CITY PLANNING COMMISSION

APPLICATION: A. Negative Declaration
B. Plan Review for a 272 Unit Apartment Complex (Section 13-3-c{4})

LOCATION: South side of Brookfield west of Franklin Boulevard at Valley Wind Way

PROPOSAL: The applicant is requesting the necessary entitlements to develop a 272 unit apartment complex in the R-3-R Zone.

SITE PLAN P 84304

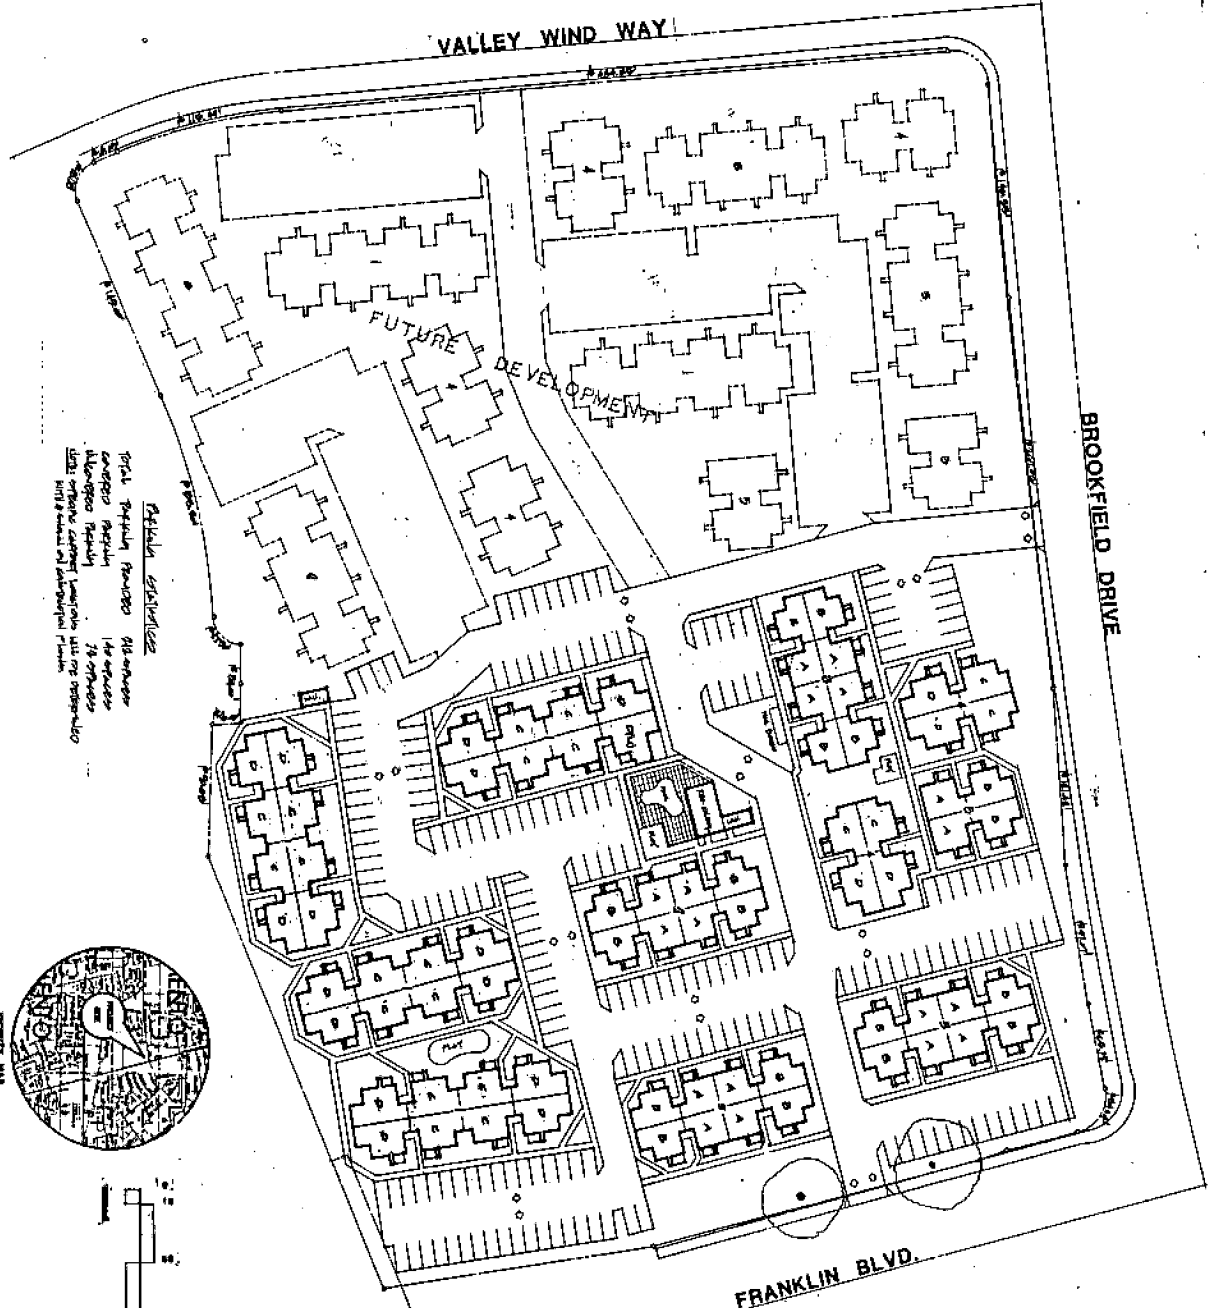
- B. As proposed, the site plan indicates inadequate landscaping both on street frontages and throughout the interior of the site. Staff recommends the applicant redesign the site plan to provide a minimum of 25 foot wide landscaped planters adjacent to all public street frontages. These planters shall be developed with a minimum of four foot undulating berms and be landscaped with turf or low ground cover and overlapping evergreen trees to buffer the site from traffic. At the present time, interior landscaping is minimal and should be redesigned to eliminate the massive paved areas. The long strips of parking stalls shall be interrupted at least every tenth stall by a minimum 5 foot planter landscaped with shade trees and living ground cover.

- F. A six foot solid masonry wall shall be provided on the south property line to provide a buffer between the complex and future development south of the site. The wall shall be planted with a clinging type vine to discourage defacement.

- G. The applicant's plans have not included details such as trash enclosures. It is, therefore, recommended that general compliance with the attached Multiple Family Residential Design Criteria be required (see Exhibit A).

1. The applicant shall redesign the landscape plans to provide the following:
 - a) minimum planter width along all street frontage to be 25 feet;
 - b) the 25 foot landscape planter shall be provided with a minimum of 4 foot undulating berms;

- c) all interior landscaping shall be redesigned to eliminate the massive paved areas throughout the site;
 - d) the long strips of parking stalls shall be interrupted at least every tenth stall with a minimum 5 foot landscaped planter.

4. A six foot solid decorative masonry wall shall be provided along the south property line. The wall shall be planted with a clinging type vine and shall be located in a landscaped irrigated planter.

5. The applicant shall submit detailed plans indicating the location and design of all trash enclosures and shall adhere to criteria in Exhibit A.
6. The applicant shall adhere to the Residential Design Criteria in Exhibit A.

EXTERIOR ELEVATIONS

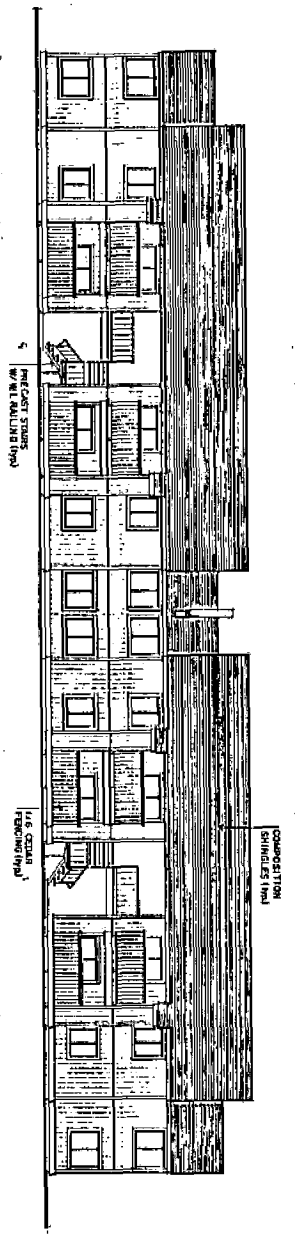
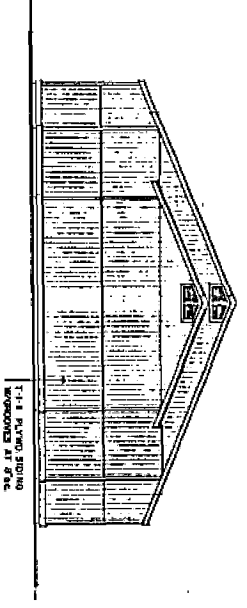
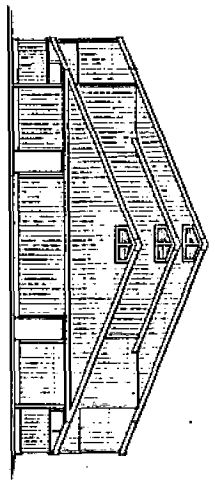
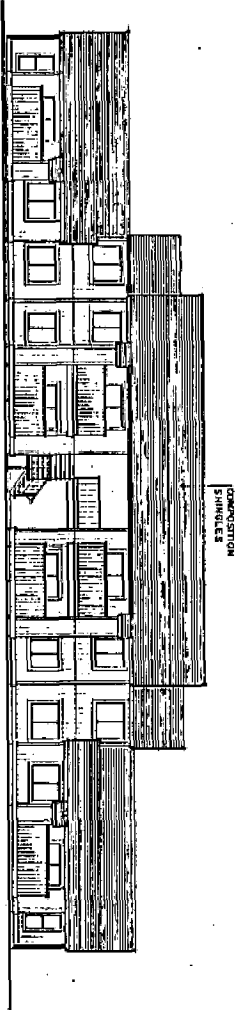
- C. To improve the visual quality of the project and provide relief and continuity to the end elevations, staff recommends the use of window elements or other design features on the blank wall of all end units.

- D. The building elevations are acceptable in that the plans indicate a variety of roof lines and the use of one and two story units. Staff does, however, recommend the replacement of the TIII plywood siding with a horizontal woodsiding which will further enhance the appearance of the apartment complex.

- E. Final detailing of exterior elevations should be submitted to staff for review and approval. It is suggested the applicant work with staff to resolve the final detailing.

2. The end units shall be redesigned with window elements or other design features which will be shown on revised elevations.
3. The siding material shall consist of a horizontal wood siding.
